ITEM 6. DEVELOPMENT APPLICATION: SECTION 96 APPLICATION TO AMEND STAGE 1 MASTER PLAN 600-602 ELIZABETH STREET, 3-5 KETTLE STREET, 66-76 WALKER STREET, 57-75 WALKER STREET, 44-52 MOREHEAD STREET AND 55-57 WALKER STREET REDFERN

FILE NO: U/01/1316/A

Figure 7 – Proposed Amendments to Approved Master Plan

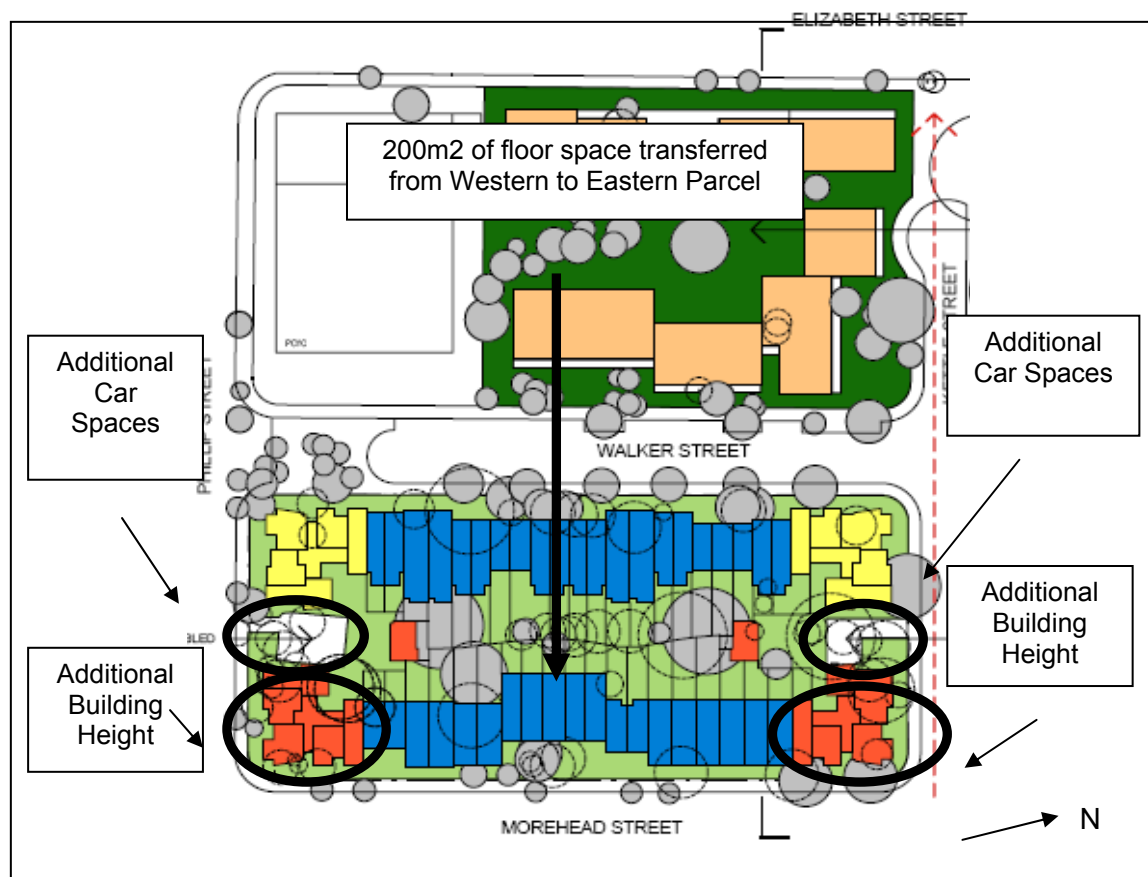
18. The Stage 1 Master Plan approved a maximum height of 9 metres for development on the eastern parcel of the site. This is consistent with the requirements of the South Sydney DCP 1997. The proposed modifications seek approval to increase the height of the buildings located on the north-east and south-east corners of the eastern parcel of the Master Plan site to a height of 11.7m.

19. The DCP allows for variations to height in circumstances where streets are more than 12 metres in width, if the application can demonstrate compliance with the predominant height and scale of adjoining buildings. The proposed development is considered to comply with the performance criteria and controls on the following basis:

- (a) The proposed development provides an appropriate transition between the high rise development located to the north and east of the site;
 - (b) The application takes advantage of the topography of the site; and

- (c) The additional height will not result in any adverse shadowing impacts on adjoining developments or the public domain.
20. Given that the application complies with the performance criteria and will not result in any adverse amenity impacts, the proposed modification is considered acceptable.

- (2) That the site layout and height in a future development application shall be generally in accordance with **the drawings annotated 'Section 96 amendment to Option 3', drawn by LFA and dated 29 May 2007** ~~plans notated Elizabeth Street Site - Option 3 and Walker Street Site - Option 3,~~ with heights not exceeding 15 metres **on the western parcel** and 9 metres, ~~respectively~~ **on the eastern parcel of the site, with the exception of the two apartment buildings fronting Morehead Street which shall have a height not exceeding RL46.5m.**
